INVACARE®

Bed Rail Selection Chart

Bed rail designs have changed over the years. Our goal is to inform you of these changes and request that you review your inventory of Invacare bed rails. If you currently use an older design, we ask that you stop using these and replace them with a newer design. The following pages depict some of the options available to you.

Full Length Rails

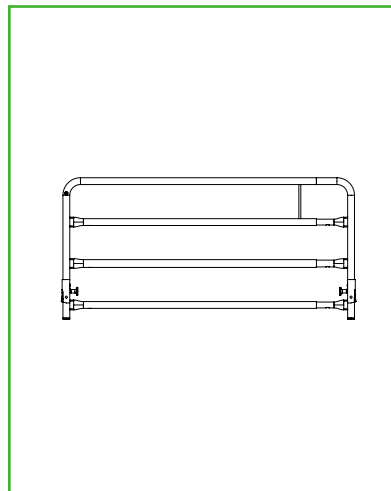
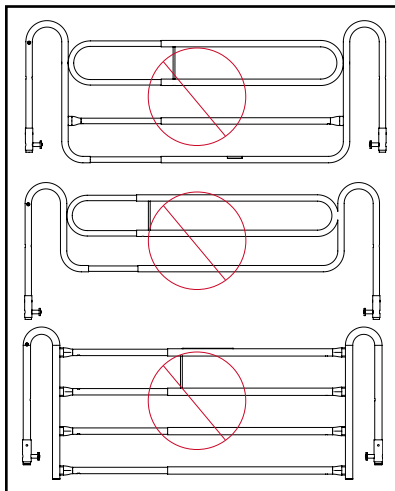
Potential Part Numbers: 6628, 6628-TSS

Note: pre-2004 rails had 3 cross bars;
2004 to present rails have 4 cross bars

Replace with 6628, 6628-TSS, or 6629

Potential Part Numbers: 6650

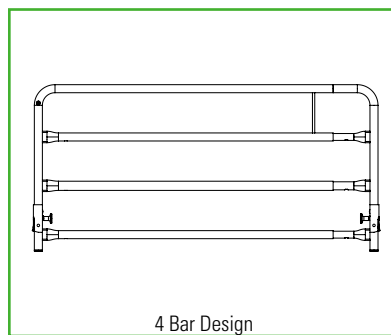
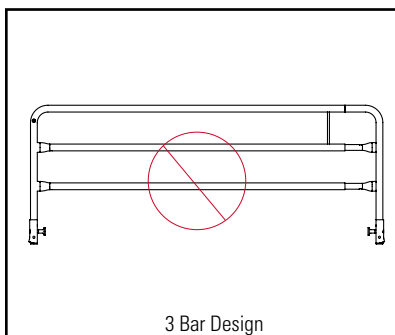
Note: 3 different designs exist

Replace with 6629

Potential Part Numbers: 6629

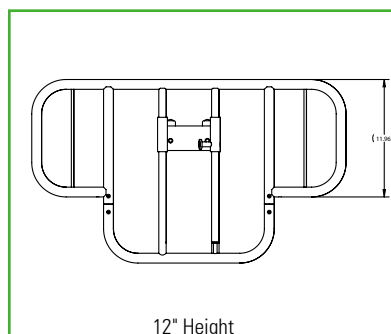
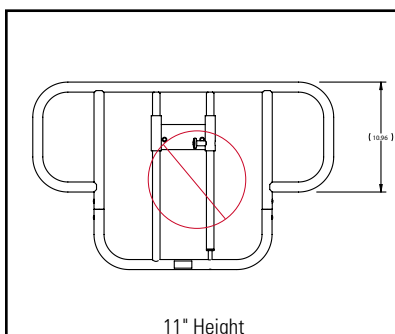
Note: pre 2004, rails had 3 cross bars

Note: 2004 to present, rails have 4 cross bars

Replace with part number 6629

Half Length Rails

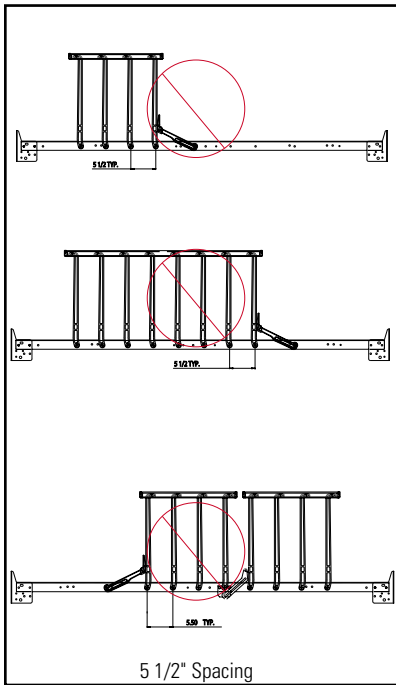
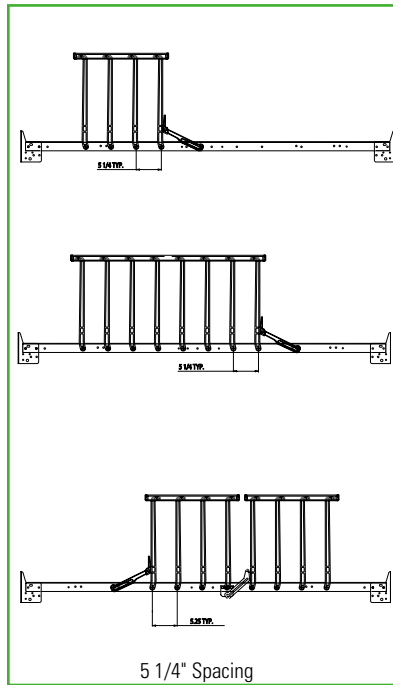
Potential Part Numbers: 6630 pre 2003

Note: pre 2003 rails had different dimensions
and no spindle; from 2003 to present,
dimensions have changed and an additional
spindle was added to close the gap.

Replace with 6630 current production

Potential Part Numbers: IH5744, IH5748, and IH5749

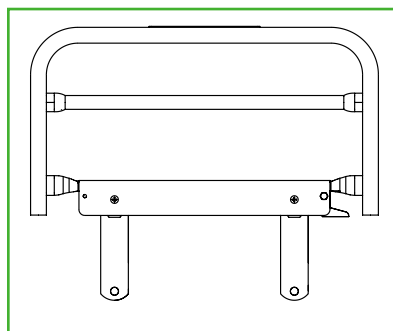
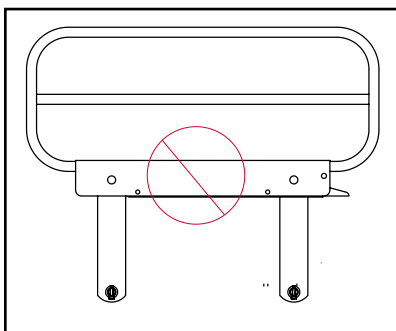
Note: If you have rails with a 5 1/2" spacing you should replace these with a different rail.

Note: Nylasar rails manufactured before June, 2005 had a 5 1/2" spacing between the rail attachment bolts. After June, 2005 the spacing was decreased to 5 1/4". While 5 1/4" spacing rails are suggested for use, they are no longer manufactured. If you need to replace 5 1/2" rails and do not currently have 5 1/4" rails, please replace with one of the following: IH6801A, IH6803A, IH6815A, IH6808A

Replace with IH6803A, IH6808A, IH6815A, IH6816A

Potential Part Numbers: IHARRLFUL, IHECRLFULL, IHARRLPAR, IHECRLPAR

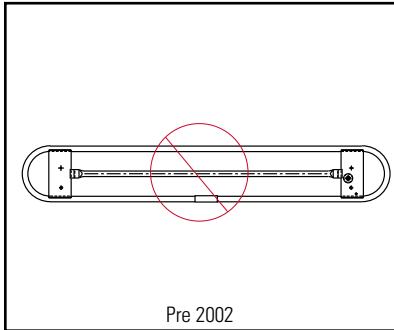
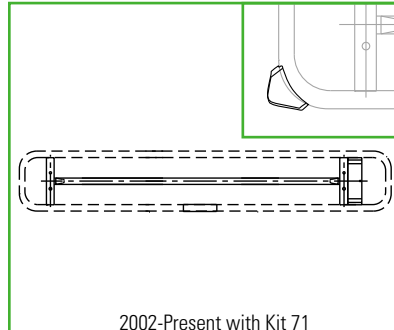
Note: Use corner adapter kit to modify your rails

Replace with current production in addition to Kit 71

Potential Part Numbers: IH5814, IH6800

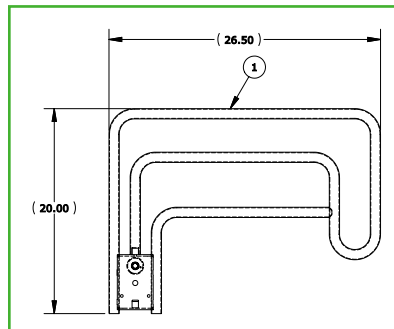
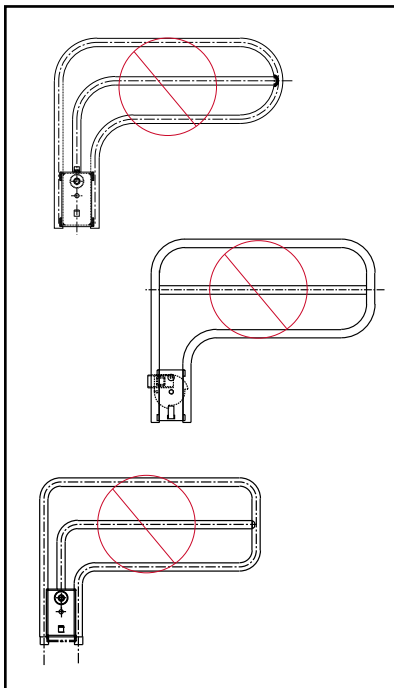
Note: Use only with Invacare® Solace® Prevention 2000 Series and higher mattresses

Replace with current production if your rail looks like one pictured on the left side
